PROJECT: 40 Princess Street B100019-AD DATE: 14/02/2024

SUBJECT: RE: Application referenced: 138904/LO/2023 - 40 Princess Street TRANSMITTAL ID: 00019

Subject: RE: Application referenced: 138904/LO/2023 - 40 Princess Street

snip which illustrates the size of the screens. Floor 8 also has a similar designed meeting room with only a glazed screen on one elevation (see attached photo 'Floor 8 meeting room.jpeg')

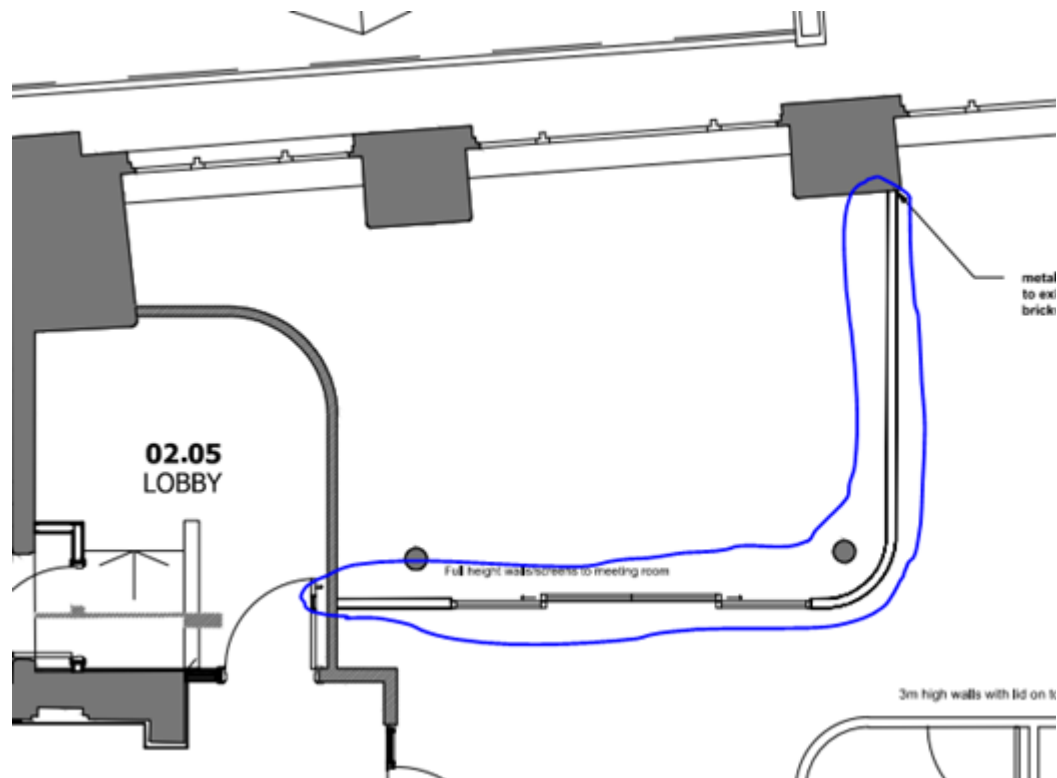
The new partition to create a meeting room is to a large degree solid and will need to be amended to be more lightweight with more glazing to its length and height especially the length that returns back to the windows. Please amend. **As this is a meeting room we have two large media screens on the solid wall, there isn't anywhere else these could be placed due to windows and the existing curved wall, therefore we are unsure where we could include any more glazing. Please see attached**
